ADDENDUM NO. 1 - OUTLINE AND SUMMARY INFORMATION

Project Name: MAES – Bart Farm Aurora Test Range Electrical PPA No.: 22-0544
Location: Montana State University - Bozeman Date: 04/07/2023
Owner: State of Montana, MSU - Bozeman
Plew Building 6th and Grant, PO Box 172760
Bozeman, Montana 59717-2760

MAES - BART FARM AURORA TEST RANGE ELECTRICAL

SHEET TITLE
SITE PLAN

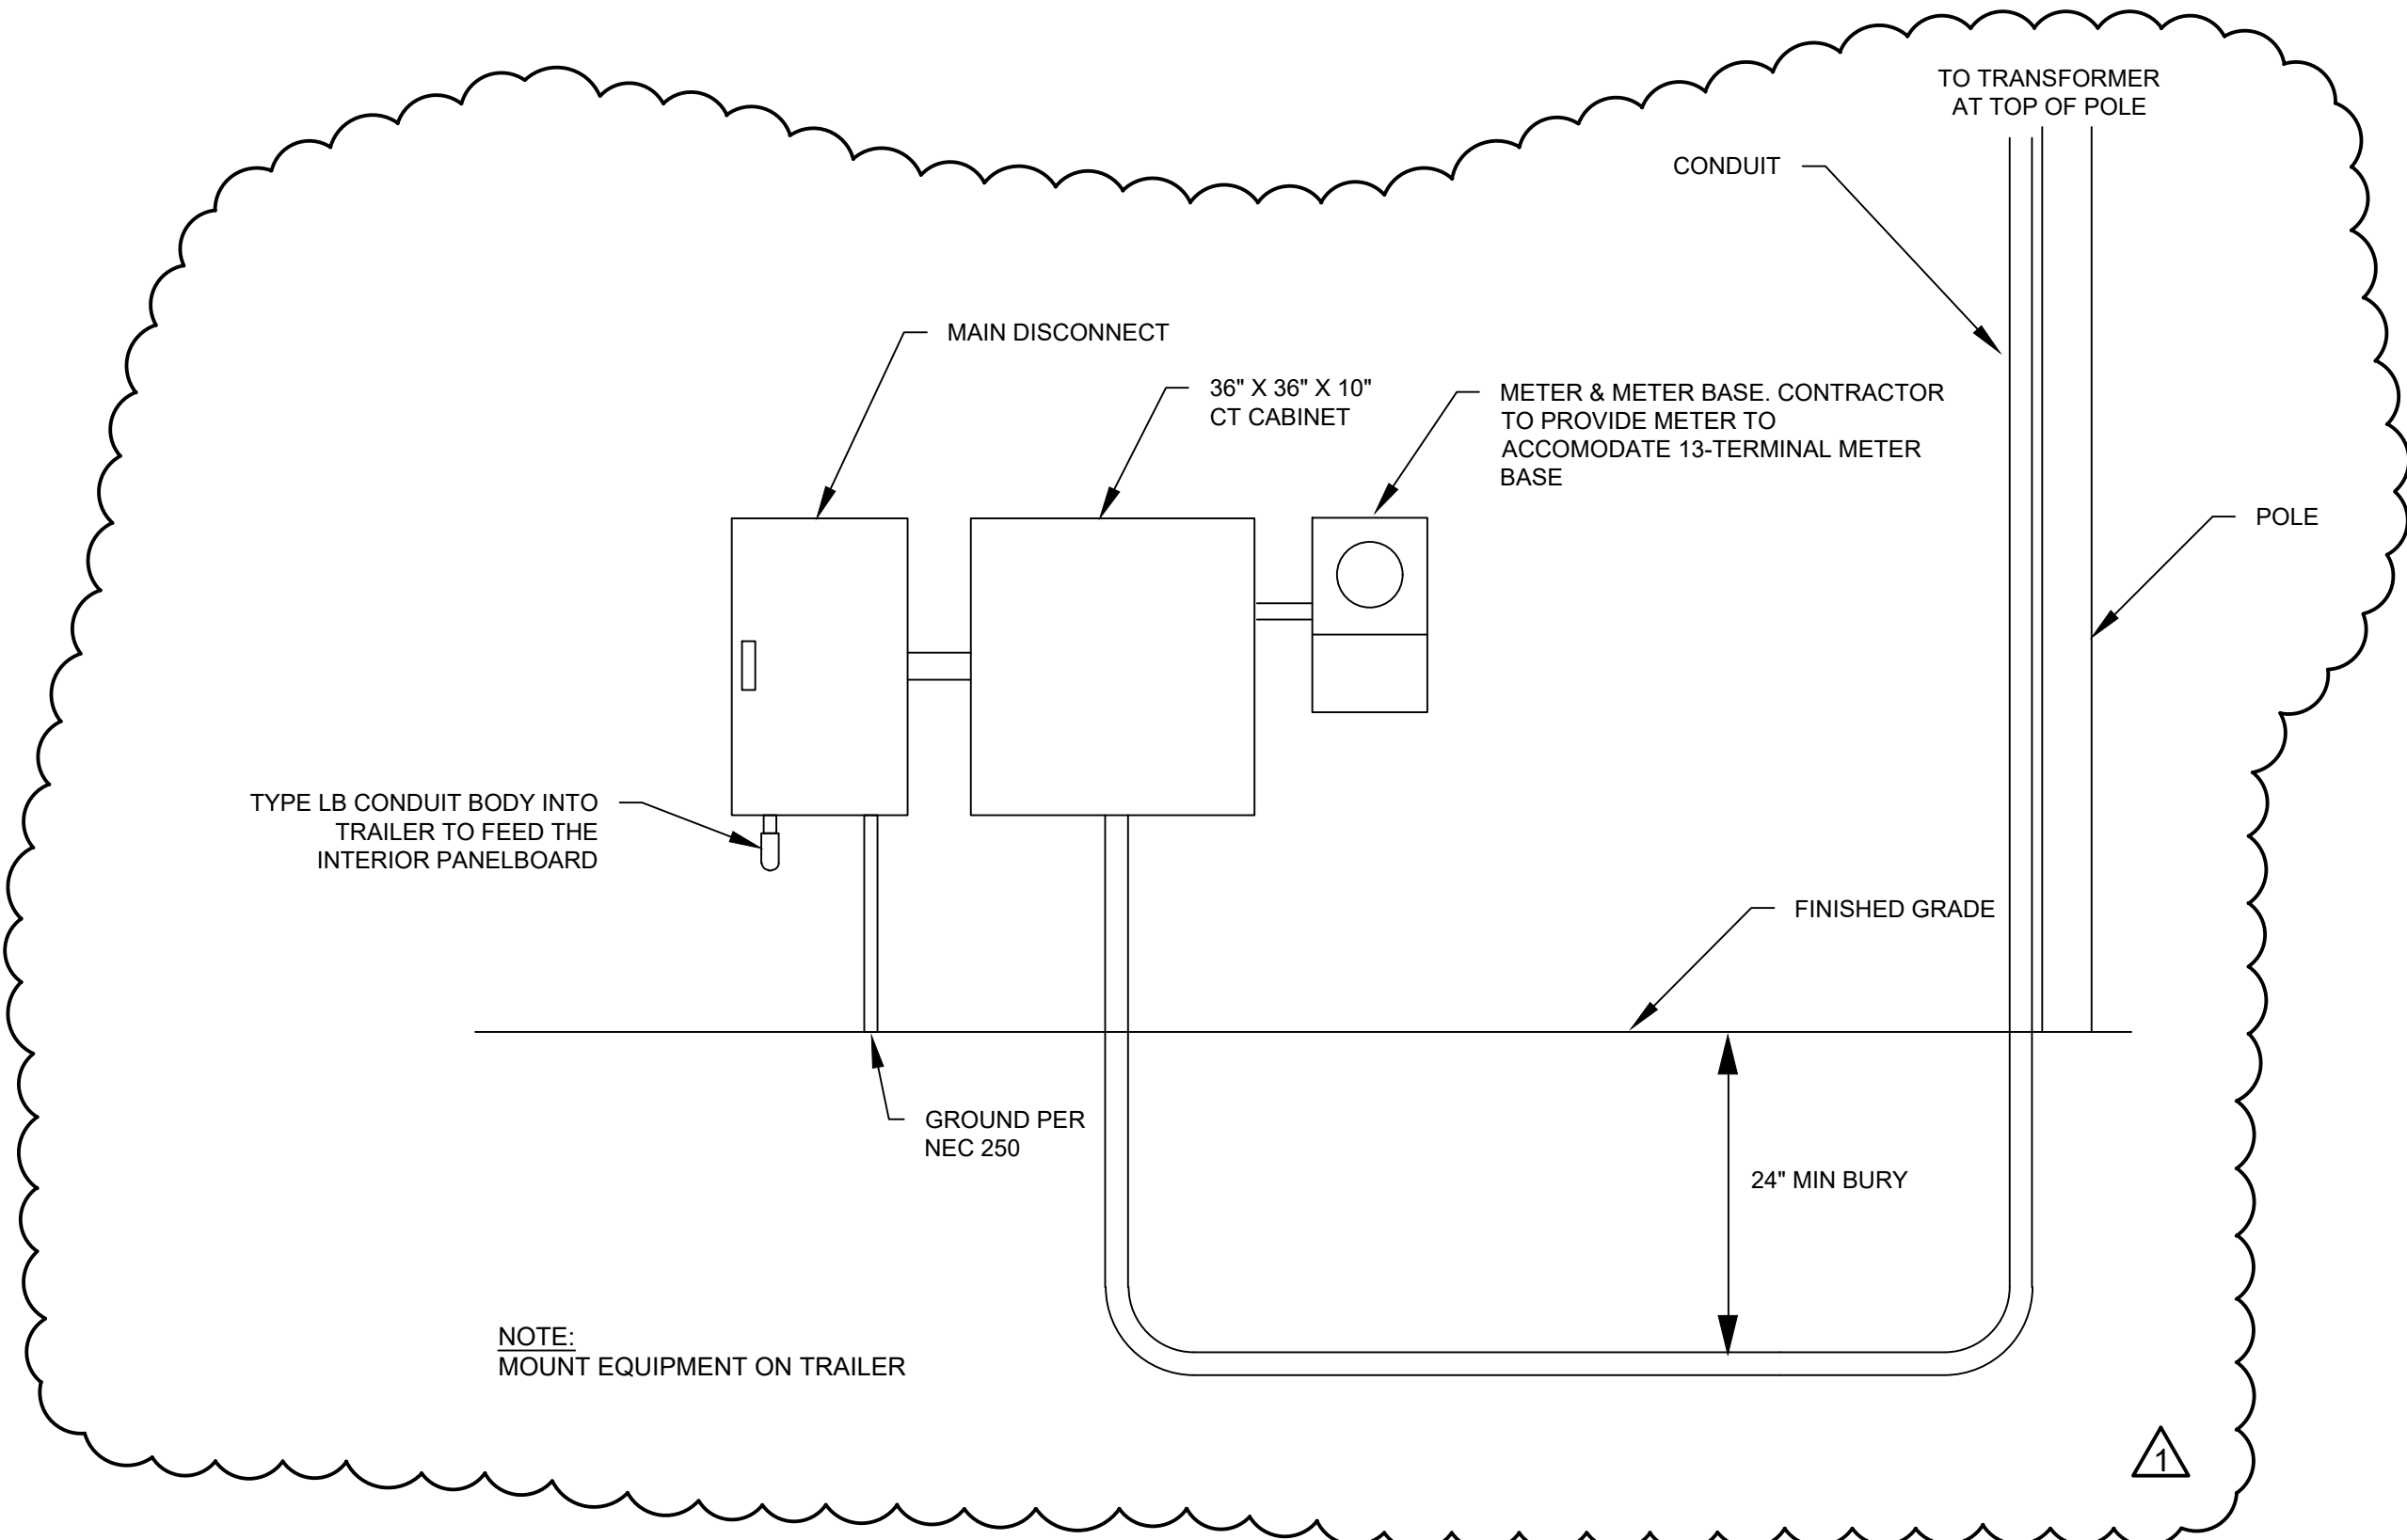
1. AMENDMENTS TO THE PROJECT MANUAL
 - a. Specifications: N/A
2. AMENDMENTS TO THE DRAWINGS
 - a. Sheet:
 - i. E-2 SITE PLAN: Service drop from pole to trailer was updated from an overhead drop to an underground drop to the service equipment. The service equipment was updated to be mounted directly onto the end of the trailer.
 - ii. E-5 DETAILS: Detail 1 was updated to show the underground service drop.
 - iii. E-6 DETAILS: Detail 1 was updated to remove the overhead service drop equipment.
3. AMENDMENTS TO EQUIPMENT INFORMATION
 - a. N/A
4. PRE-BID MEETING INFORMATION
 - a. Project has been submitted to the City of Bozeman and approved. Permit shall be picked up by the Contractor that is awarded the project.
